As part of the Dean Ave reconstruction project design (ID 11432), Traffic Engineering was asked to evaluate a lane configuration modification on westbound Dean Ave approach to Monona Dr. Alternates analyzed include:

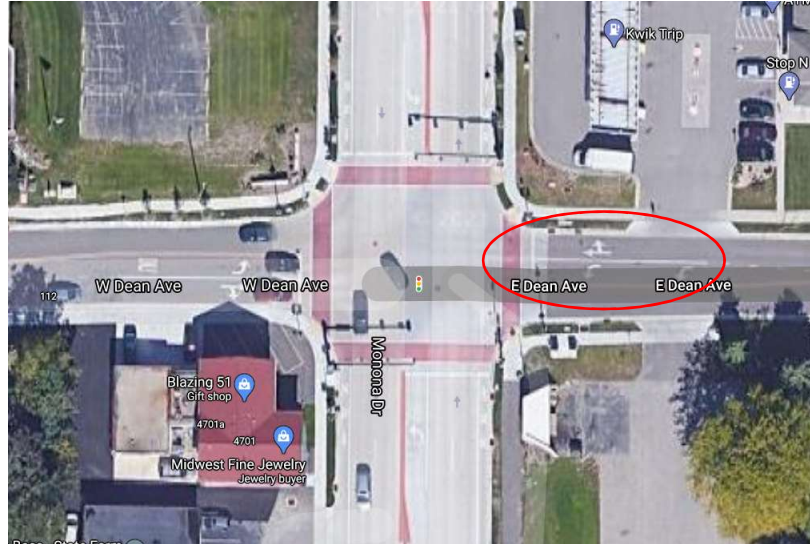
- Current lane configuration (see below) of left-turn only (11-ft) & thru/right (11-ft), and
- Proposed single shared left/thru/right lane (17-ft) with advisory bike lane (5-ft).

Analysis results indicate a predicted modest increase in delay, volume-to-capacity ratio and queue lengths if the left-turn lane is removed. The analysis used the existing coordinated signal cycle length, with optimized splits for each scenario.

While the effects of operational impacts are generally considered tolerable, other considerations regarding modification of the current lane configuration on westbound Dean Ave approach to Monona Dr should include:

- Prior to being reconstructed in 2013/14, this approach was marked as a single lane. It was changed to its current configuration, in part, based on specific requests from neighborhood residents.

- Given available width, the existing lane configuration accommodates the peak hour turning movement proportions of left-turns to through/right-turns that are: 45%, 34% and 22%, respectively.

- The current configuration aligns the opposing left-turns (which can allow for improved sight-distance) allows through-movements to cross the intersection without deviation within the intersection. The opposing (eastbound) lanes are likely not to be modified since within City of Monona jurisdiction.

- Based on the analysis, an increased in queue length in the westbound direction is likely to result more routinely. These queues may block the driveway to the gas station/convenience store in the northeast quadrant of the intersection.

- Through-vehicle movements may attempt to bypass left-turns waiting for opposing traffic. While allowable under [state law](#), this may violate expectancy of other road-users at the intersection.

Based on the factors above, it is generally desirable to maintain to existing lane configuration or consider a lane configuration alternative that allows for dedicated left-turn bay while transitioning the proposed advisory bike lane to a bike box at the intersection, if possible.
